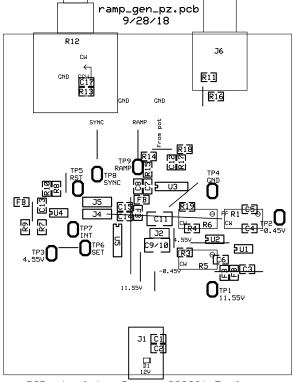
Replaced R1 & R2 with 10K pot to set duty cycle independent of frequency.

Changed C9-11 to 0.1uF/16Y/1210 size ECHU series caps with PPS dielectric (no dc/dv).

Removed J3 (only two cap timing choices).

Changed pots to 200K and R3 & R4 to 27K. Fixed integrator inputs (U3A).

Added PCB name & date to copper.

Made R18 10 times smaller and put it inside the feedback loop (GND had a 200mV ramp).
